# **GROUNDWATER FLOW AND TRANSPORT MODEL EVALUATION AND DEVELOPMENT**

**TOOELE ARMY DEPOT  
TOOELE, UTAH**

**Contract No. DACW05-00-D-0010  
Task Order No. 7**

**GROUNDWATER FLOW AND TRANSPORT MODEL EVALUATION AND  
DEVELOPMENT  
TOOELE ARMY DEPOT, TOOELE, UTAH**

**FIGURE 3-14**  
**Head Versus Time North of Bedrock Block**  
**at Monitoring Wells Near E-11**

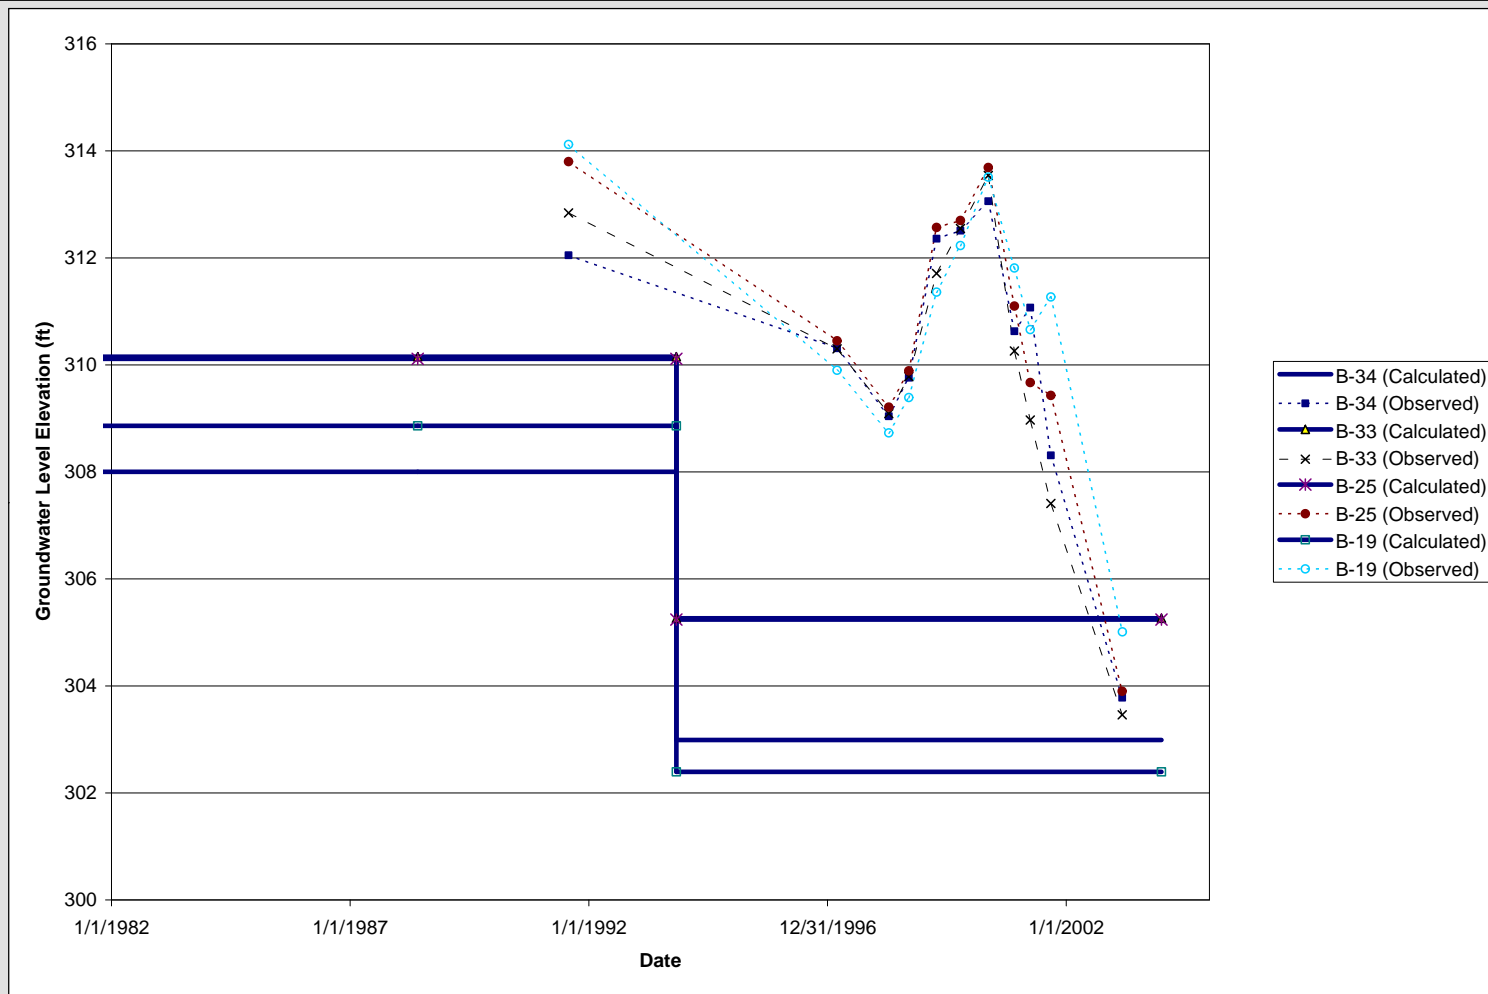
- Near E-11: the model predicts currently observed water levels, but under predicts drawdown by factor of two. A significant period during which water levels recovered is not simulated (Figure 3-14).

**FIGURE 3-15**  
**Head Versus Time North of Bedrock Block**  
**at North Edge of Main Plume**

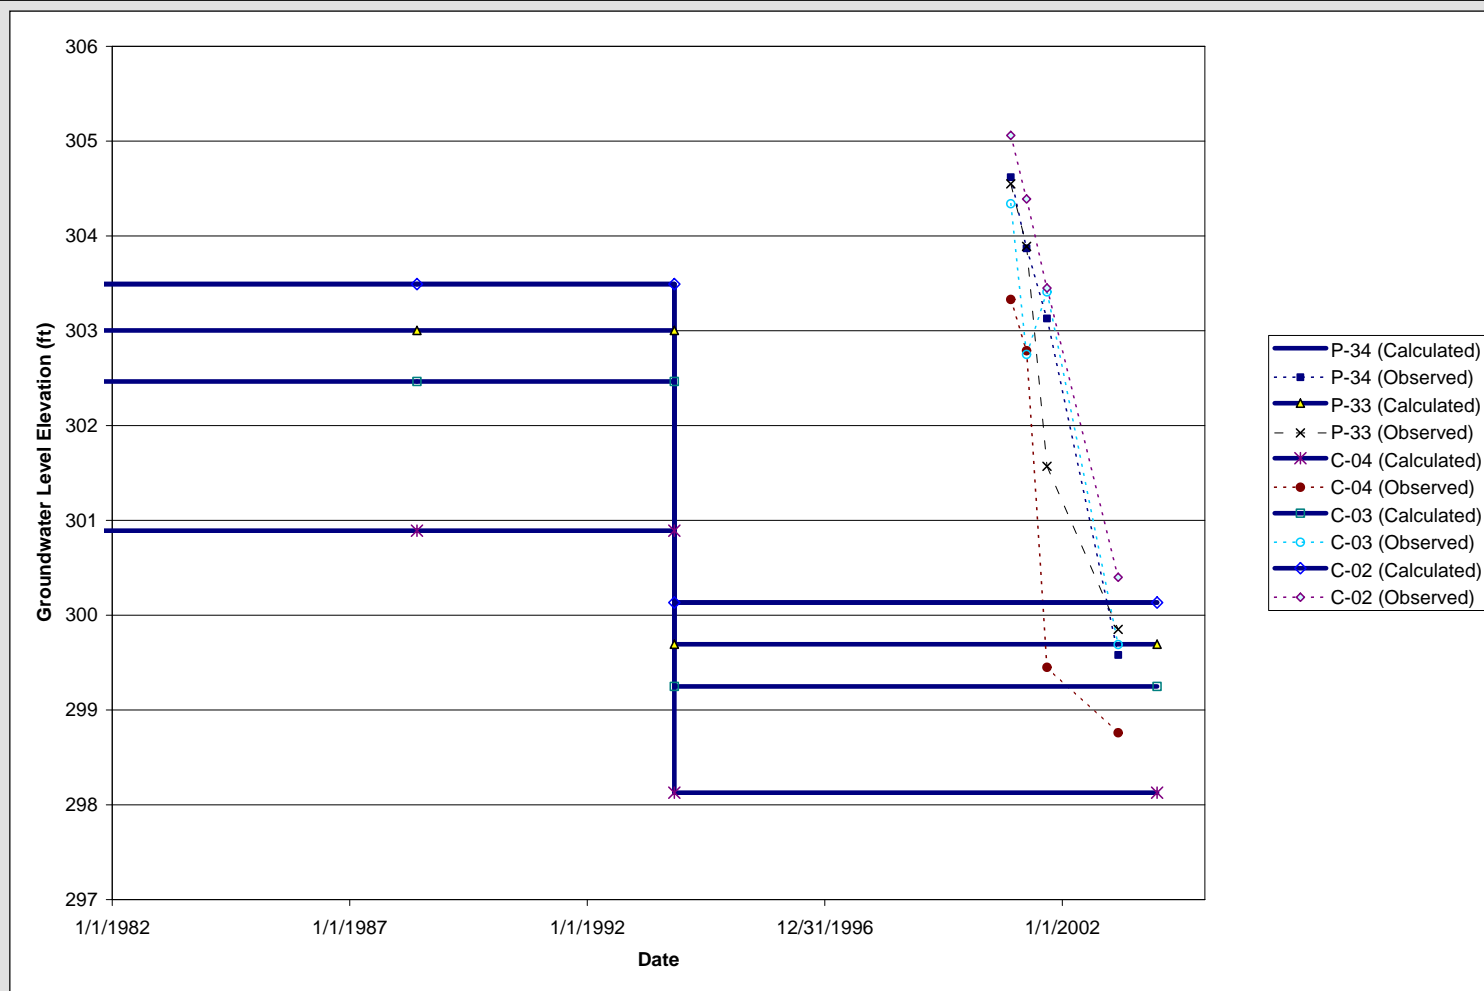
- North edge of plume: Model accurately simulates currently observed water levels, but the predicted drawdown and capture may not be accurate because of the lack of pre-pumping data (Figure 3-15).

**FIGURE 3-19**  
**Predicted and Observed TCE Concentration**  
**Time Histories In the Main Plume**

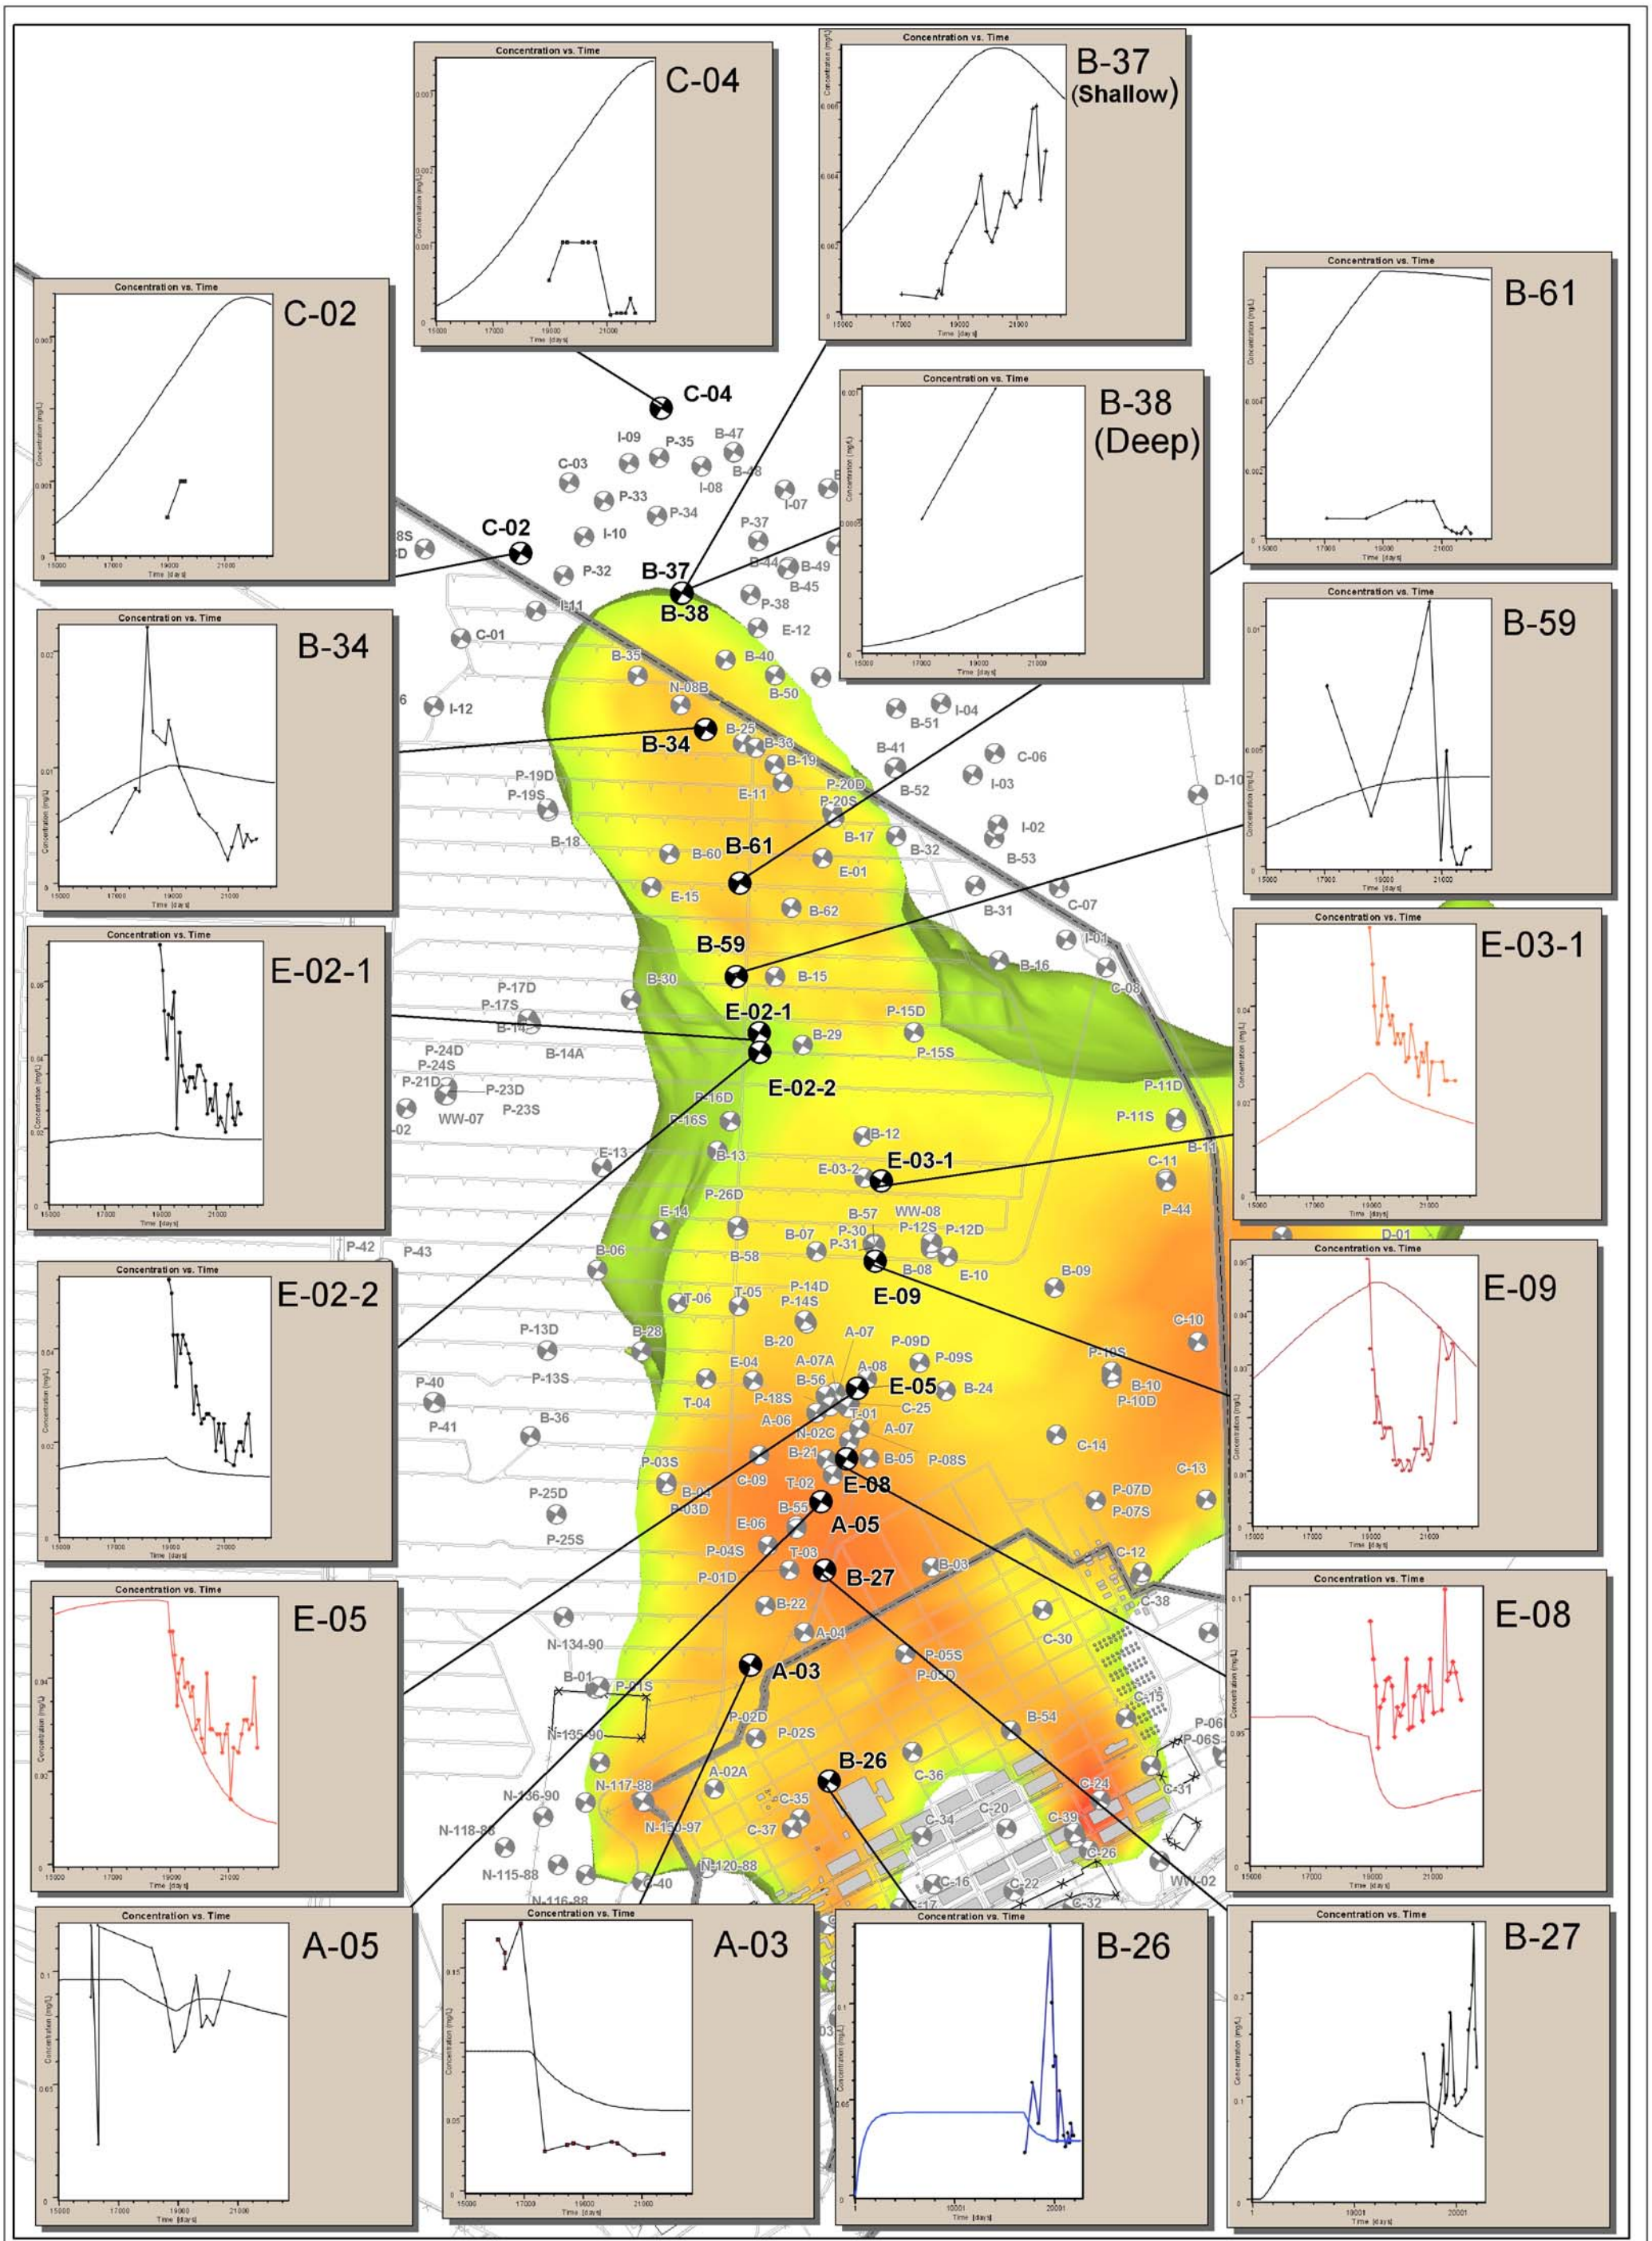
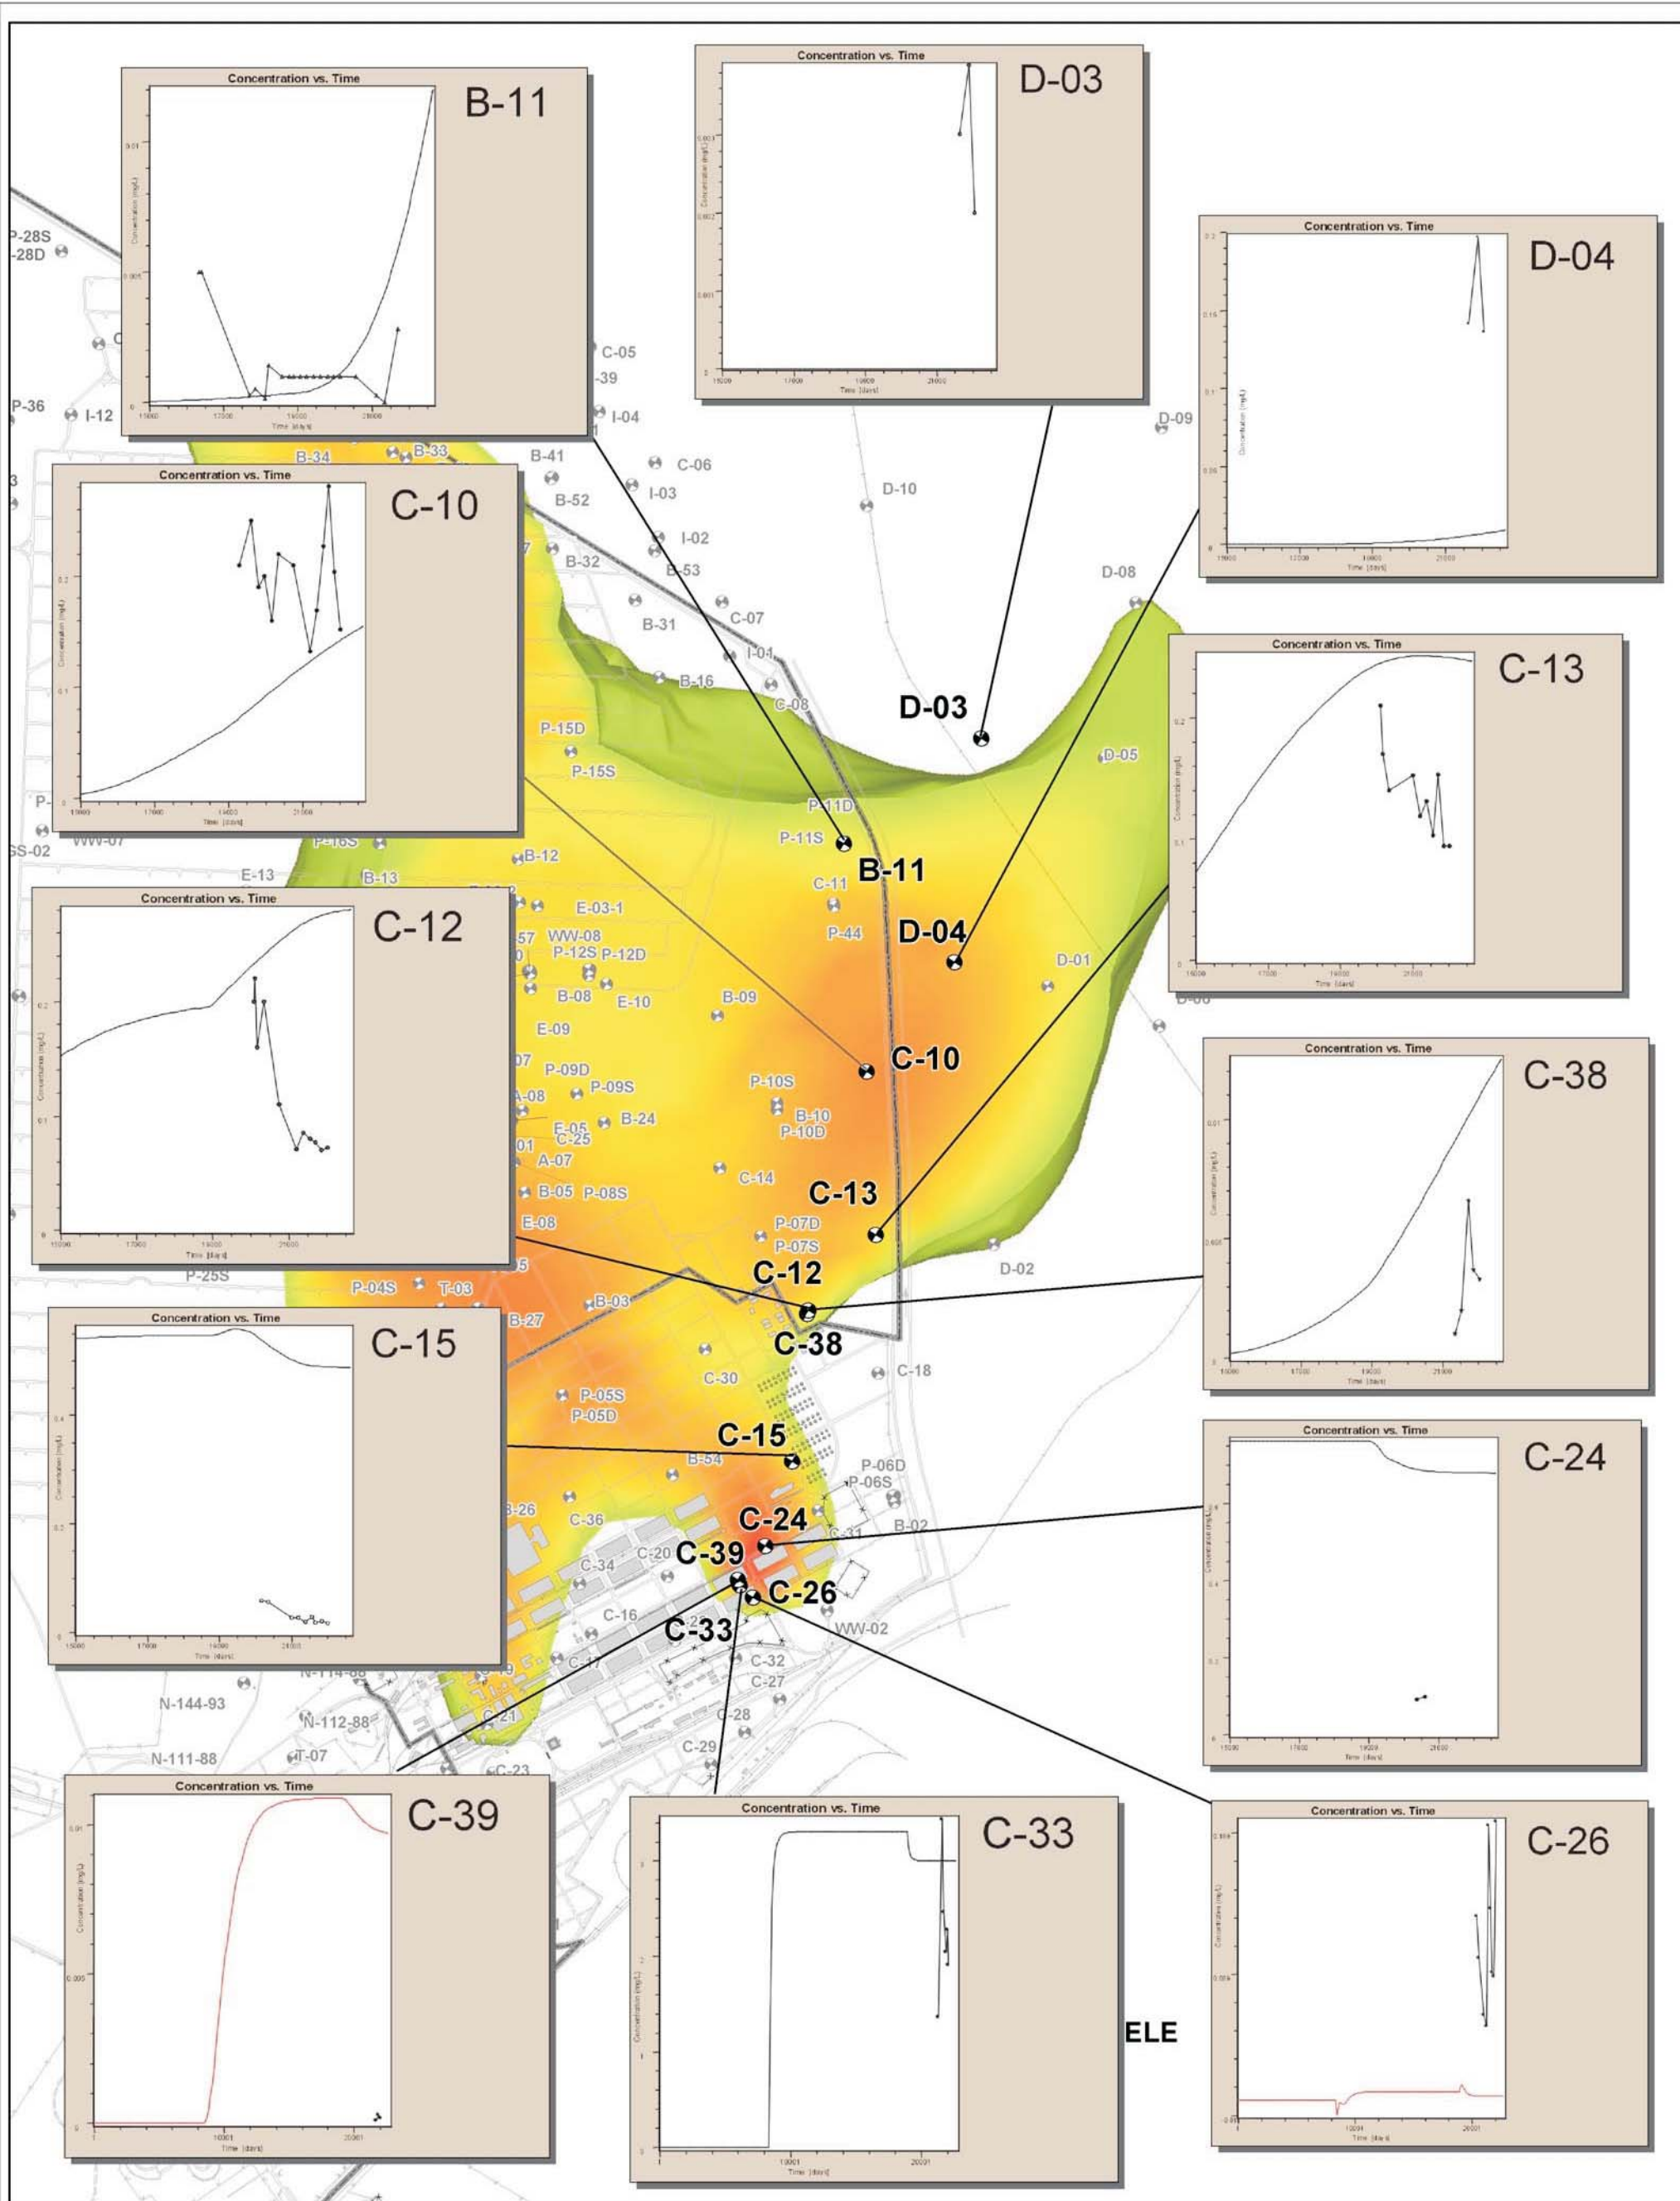
Figures 3-19 and 3-20 show predicted and observed concentration time histories along the centerline of the main and NEB plumes respectively. Trends and differences between predicted and observed concentrations are exaggerated in these figures, which use a linear scale on the y-axis showing TCE concentrations in mg/L. It can be seen that in both the main and NEB plumes observed concentrations are generally trending downward. Predicted concentration trends show downward trends in the main plume and upward trends in the NEB plume. This means that future predictions for the main plume are likely to be more realistic than those for the NEB plume, which may exaggerate the future concentrations at the locations evaluated. There are locations in the NEB plume where TCE concentrations are under-estimated, but these concentrations may potentially be explained by the additional source locations described earlier

and the higher conductivities observed in this area – neither of which is incorporated in the current 2003 model.
